AUCHTERARDER PRIMROSE PARK

CONCEPT DESIGN : EQUIPMENT & LAYOUT MAY VARY

09.03.2022

ADDRESSING POINTS RAISED BY THE COMMUNITY ON 12.02.2022

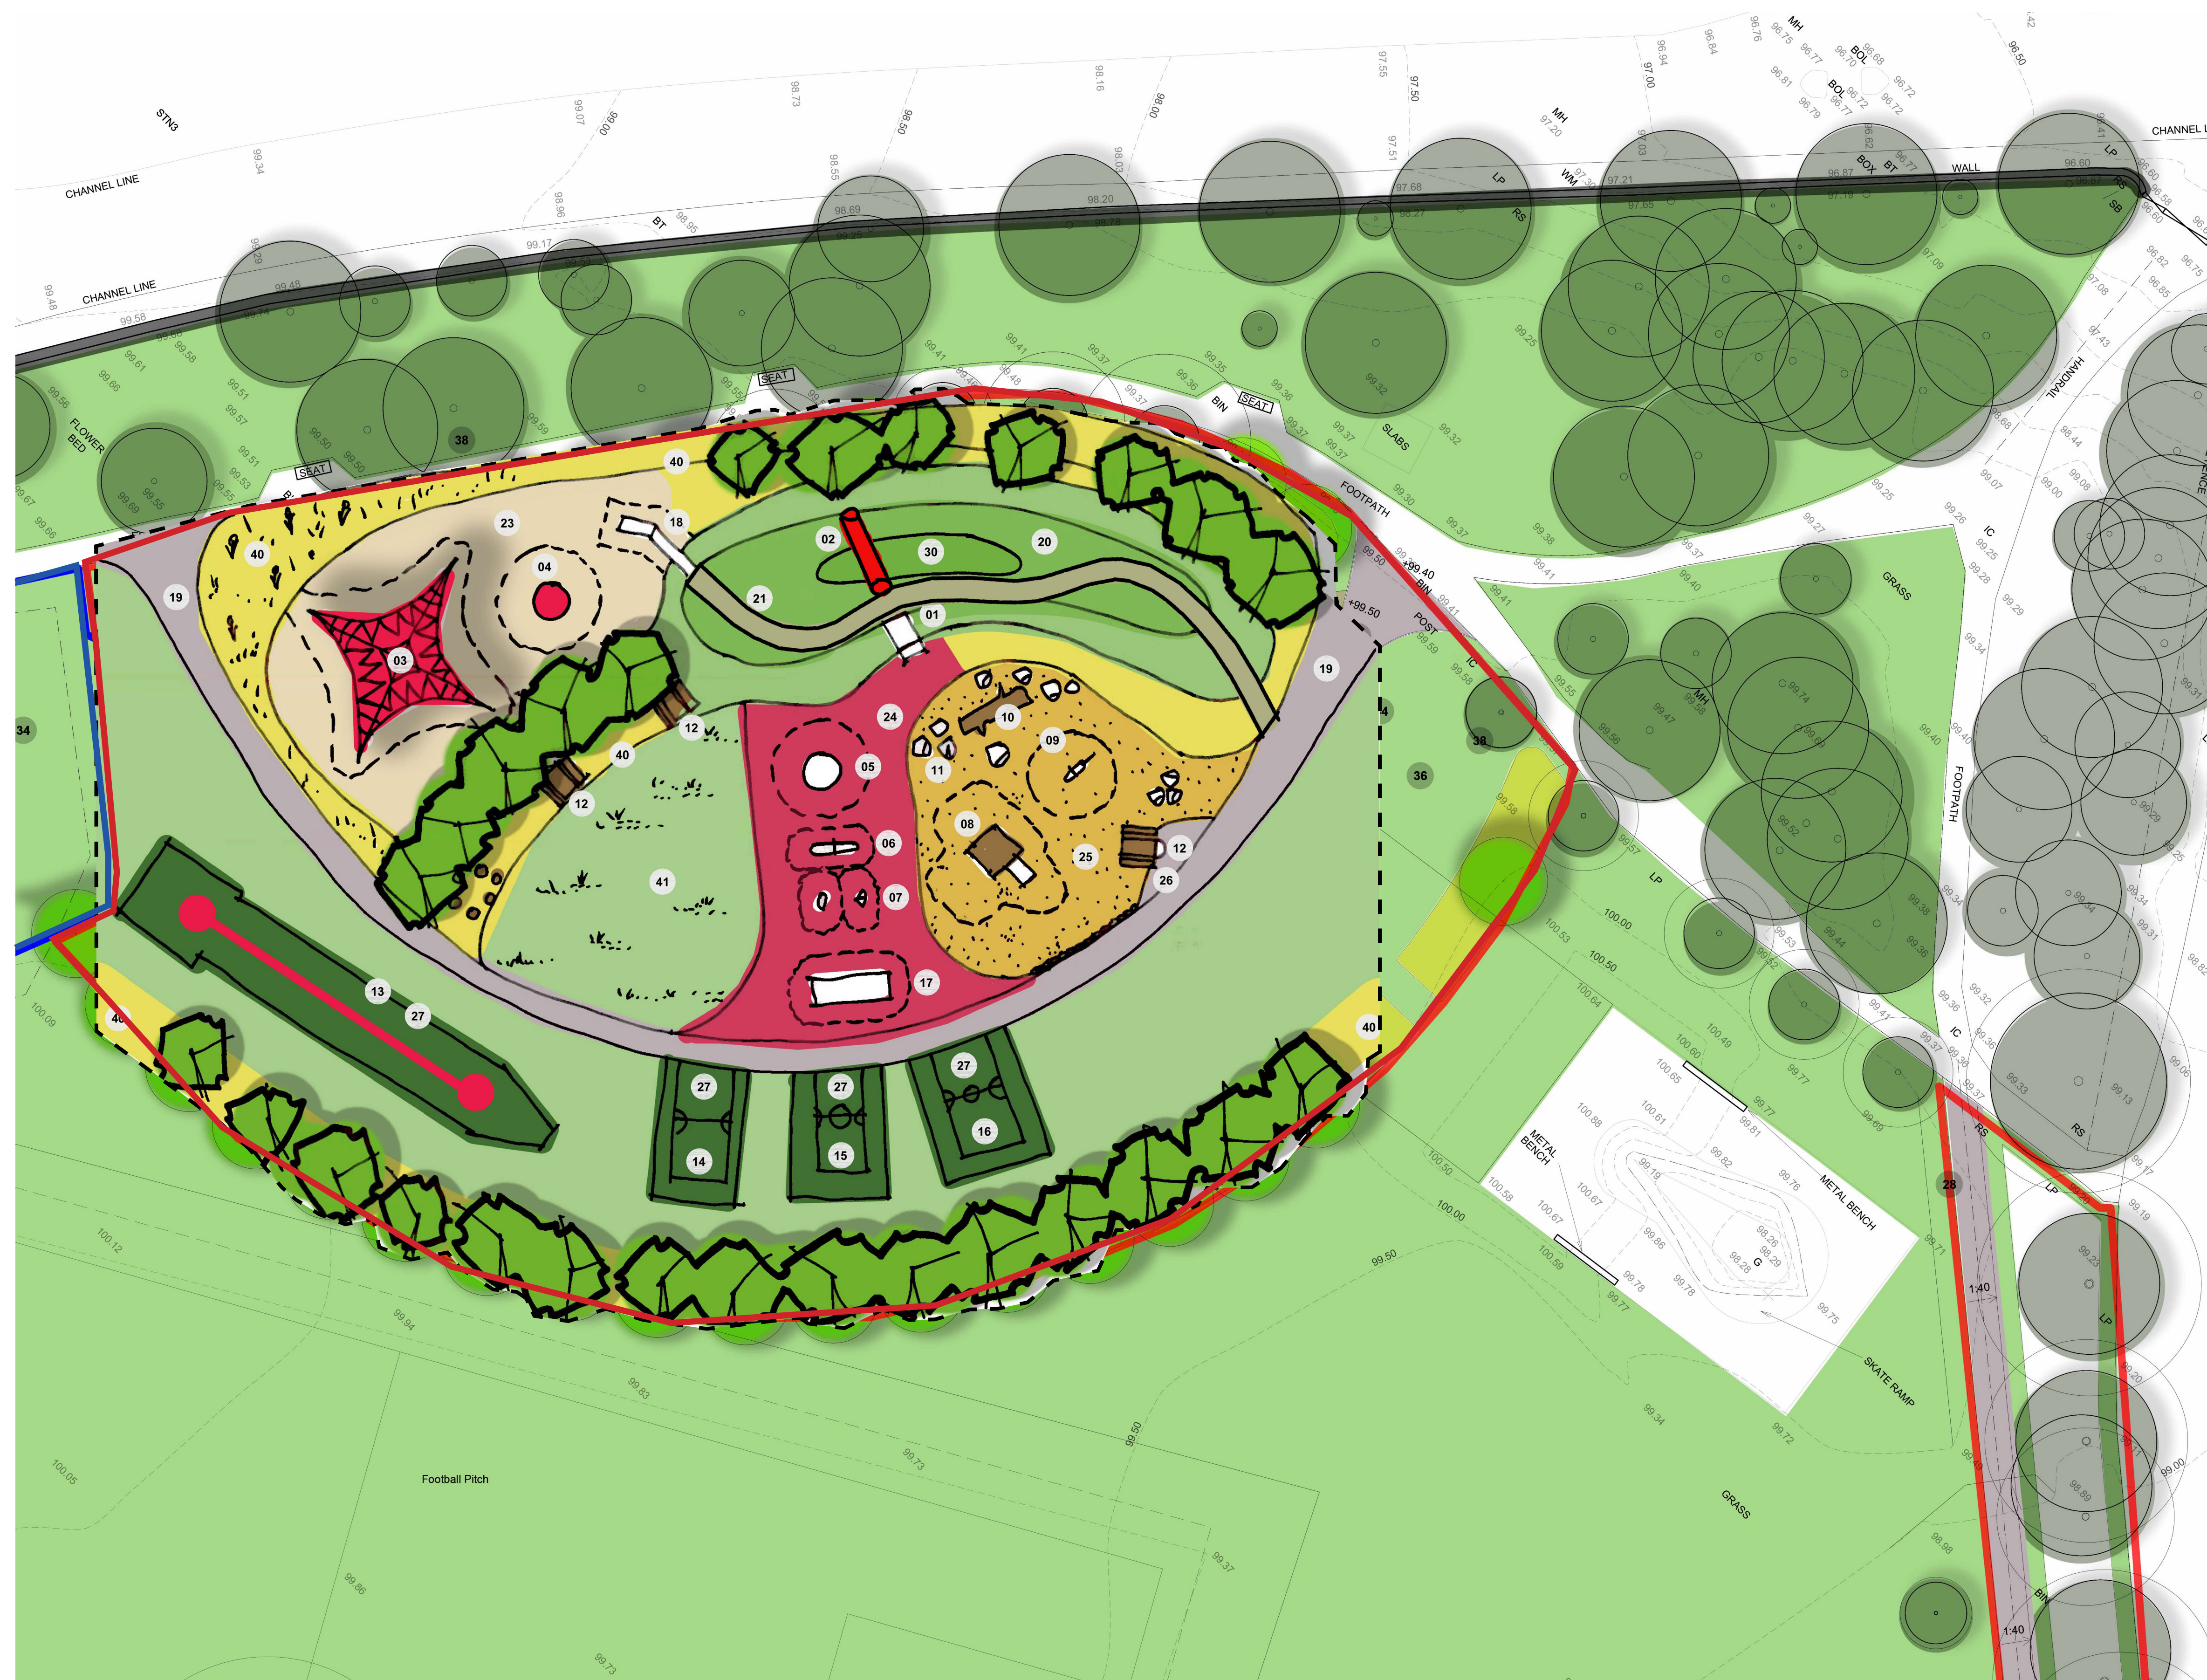
A. Could the big net be moved towards the main road and rotated so it is a focal point?

B. Can the main pieces be clearly viewable from the road?

C. Can the Senior slide be rotated through 90 degrees?

F. Can there be 'height and humps' (mounds) on the football pitch side?

G. Can the picnic benches be spread out as well as the swings?

H. Can the large climbing net be linked to the large slide?

I. Can there be softer edges (less straight edges) to the different ground coverings?

J. Can there be an add on to the sand play equipment of buckets (chain pulleys) – like at North and South Inch?

We have adjusted the design to increase visibility of the new play park from the road, with the climbing net and slide mound positioned accordingly.

Please see A.

To accommodate the desire for visibility, and by altering the layout of the different play zones, the design evolved to include a rotation of the slide.

'Height and humps' form a key part of the design of the play park for the slides, also as play features in themselves around the park as the detail design takes place.

We have accommodated the spreading out of picnic benches within the design to facilitate different locations for seating and play zone interaction. The swings have also been spread out within this new sketch design.

We will review connecting the net to the slide as detail design progresses and the specification of the net is discussed with the supplier.

Softer edges have been incorporated within the design and the different mounding features.

A timber sand play structure (see sketch plan and equipment photos) in addition to the sand digger have been added to the design providing a greater diversity of sand play value overall.
